DESIGN REVIEW COMMISSION (DRC) STAFF REPORT

**SUBJECT: MULTI-FAMILY RESIDENTIAL PROJECT AT THE
NORTHWEST CORNER OF MAIN GATE ROAD AND "C"
STREET
P2013-040; DESIGN REVIEW
APN 157-980-05; MAIN GATE ROAD AND "C" STREET**

Illustrative Site Plan

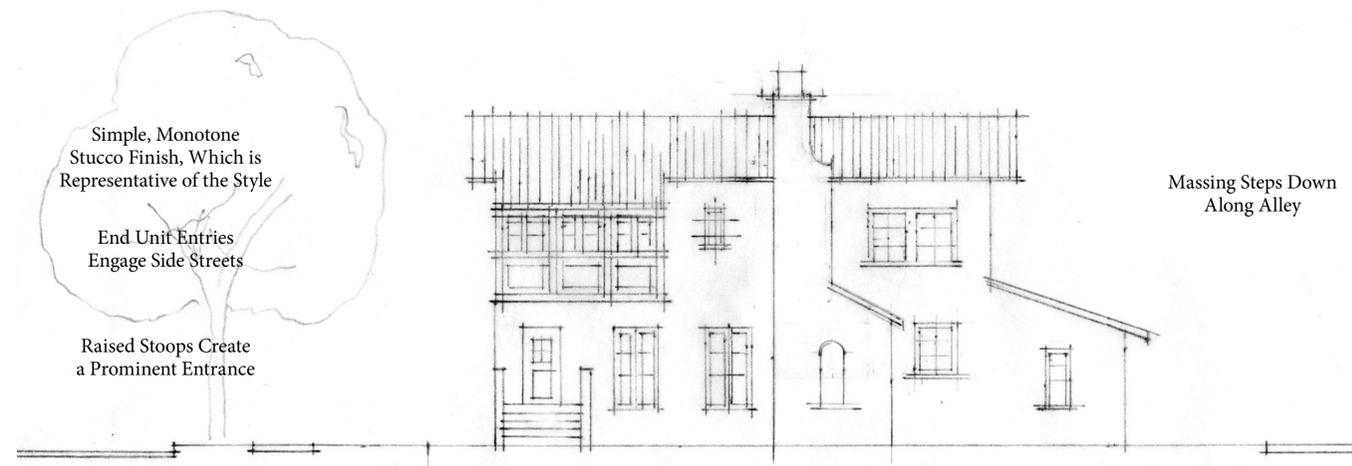
Commissioner Telfer: The elevations show much more complex details, but site plan is much more blocky. Are you assuming block forms on site plan will fit roofs? Or will roof stick out more?

John Miki: On 3-story buildings, there are protrusions that will fit into footprint of site plans. However 2nd story balconies will protrude more than what is shown on the site plan.

Commissioner MacLeamy: The difficulty with Scheme D is a double loaded alley can be an oppressive place. Only during midday would there be light. Beauty of ring road is it a single loaded alley. North and the West of the site have single loaded alleys, room for landscaping, and privacy fence separating school property. Alleys can be elegant places if planned properly. Scheme D- has single loaded alleys except for on C Street. With Scheme C, 3 units facing street is less than ideal but at least there are single loaded alleys. Issue with Scheme C, instead of green facing all units, there are garage units. Going to see them on C Street and Main Gate. I think there is a way to do this with good design. There is an internal ring road and I am imagining a wall. Even with Scheme D, front doors facing Main Gate road, you need to have at least a low wall to provide some separation to front doors facing street. You could easily have a wall that obscures garage fronts and provide a peekaboo into green space with a little work. Those front doors facing the street are aesthetic tokens to put a good face on things. If you are in Northerly or Westerly units facing park, there is chance for private
